## SYDNEY SOUTH PLANNING PANEL - ASSESSMENT REPORT

| <b>DA Number</b>   | DA-503/2018   |
| <b>Proposed Development</b>  | Demolition of existing structures and the construction of an eight (8) storey shop top housing development comprising 4 x commercial tenancies on the ground floor and 62 residential apartments above and four (4) levels of basement parking.   |
| <b>Street Address</b>  | 41 Broadarrow Road, Narwee  |

### **The proposed variation**

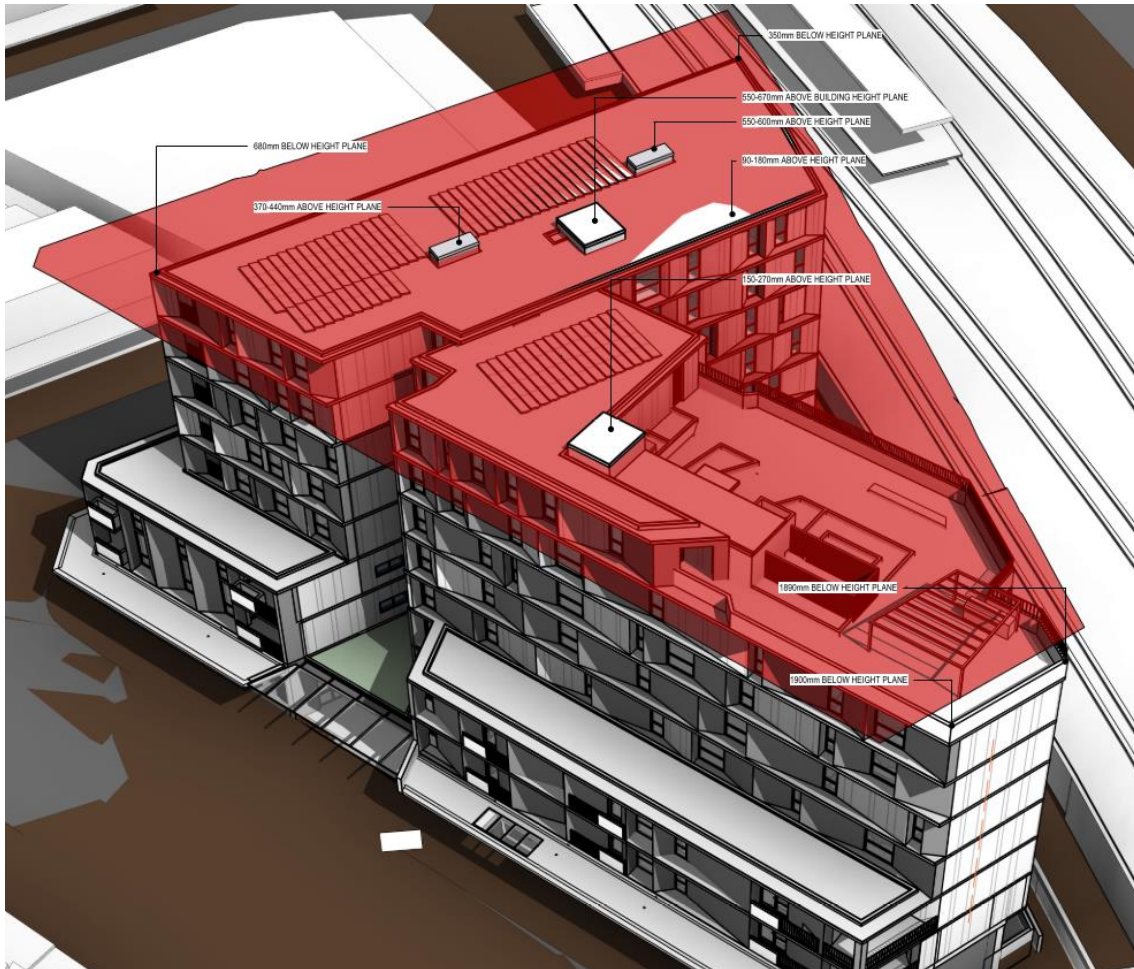
[1] The proposal complies with the development standards contained in CLEP 2012, except for Clause 4.3 – Height of Buildings. The non-compliance to the building height derives from the provision of the lift overrun, skylights and a portion of the roof above the central courtyard.

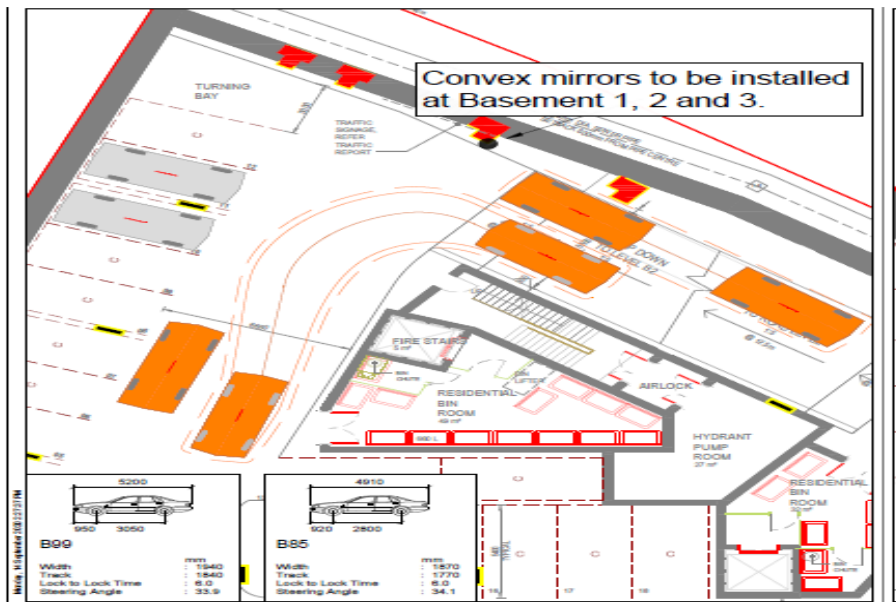
The proposed development was referred to Council's Traffic Engineer and Development Engineer for comment who are not satisfied with the proposed vehicular access and parking arrangements for the following reasons:

Council does not support the proposed strobe light system. The applicant is required to offset wall to facilitate the required driveway sight triangle in accordance with AS 2890.2. This is critical given there is a train station nearby and high pedestrian foot traffic is expected via Hurst Place railway underpass.

Given the scope of the development, Council does not support the proposed convex mirrors as an alternative to the lack of passing spaces and blind spots at the key north-west ramp intersections in the basement carpark level. The swept paths provided by the applicant does not show passing opportunities or good driver vision to allow drivers to navigate one at a time at these intersections. Applicant is to provide a B99 and a B85 passing one another at these intersections or good visual, as per AS 2890.1.

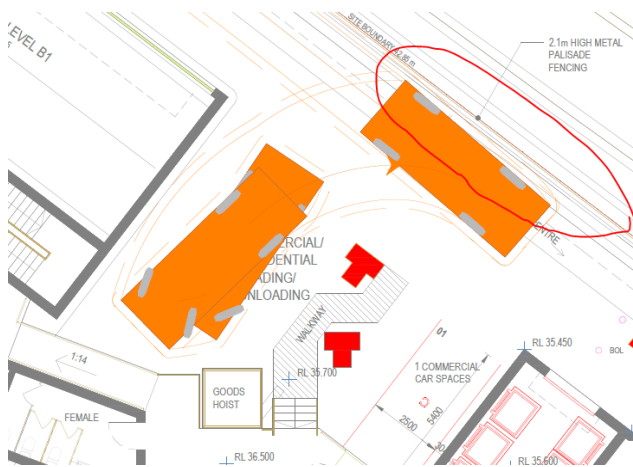
The outer body and clearance of the Small Rigid Vehicle (SRV) proposed to serve the commercial bins and commercial loading and unloading bays, appears to scrape the fence line. Applicant is to clearly demonstrate there is a clearance from this fence line and to use distinguishable lines to differentiate vehicular swept paths and boundary fence.
